# **SERVICE LETTER 240**

INSTALL TOP DECK PUMP OUT CUP DUCKBILL VALVE

Aircraft Makes/Model(s):	Aircraft Makes/Model(s): Float Model(s): Compliance		By: MAS
		Part Number: 1011979	Approved: DRH
All Aircraft	All Float Models	Date: 2/21/2023	Revision: D

New 1011075 Assembly, Pumpout Plug, Duckbill

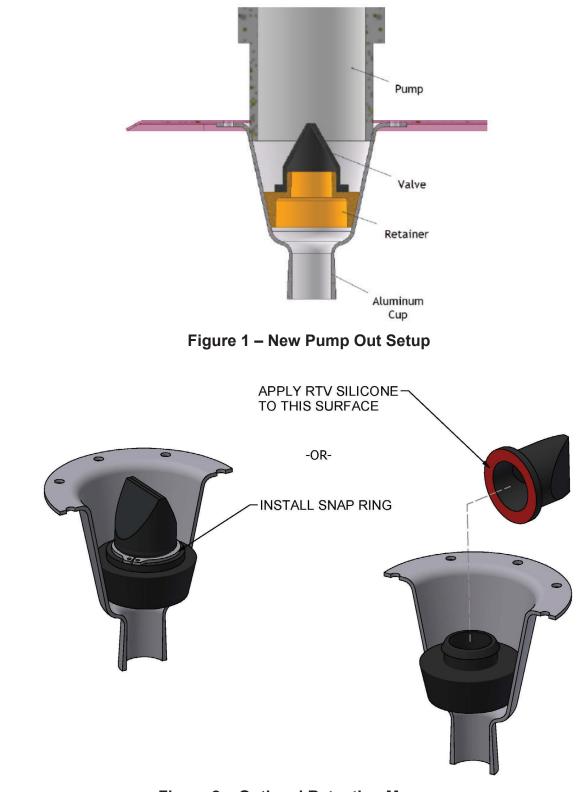
Pump out plugs p/n 2111 do not always stay lodged in the cup. A new design includes a retainer that is installed in the cup with clear RTV adhesive (or equivalent) and a rubber, replaceable "Duckbill" valve. This will also allow pumping out water from the float without pulling the plug. See Figure 1 at the end of this service letter. This letter also describes optional methods for increasing retention of the rubber duckbill component, which can be especially useful when exposed to contaminating fluids or prying wildlife.

- 1. For each pump out cup:
  - a. Remove the current plug
  - b. Clean the cup from dirt and debris. Use IPA or proper cleaner as prep for adhesive.
  - c. Using clear RTV or equivalent (any color can be used), install the retainer in the cup.
  - d. After adhesive has cured, install the duckbill valve onto the retainer.
- 2. (OPTIONAL) Additional measures for retention of duckbill valve (see Figure 2):
  - a. Using snap ring pliers, install snap ring (see table for p/n) so that it is seated against the upper surface of the duckbill valve flange but below the barb of the retainer, or:
  - b. Clean the mating surfaces and apply RTV below/around the duckbill valve flange where it meets the retainer. Beginning with a few light dabs is recommended, increasing as required.
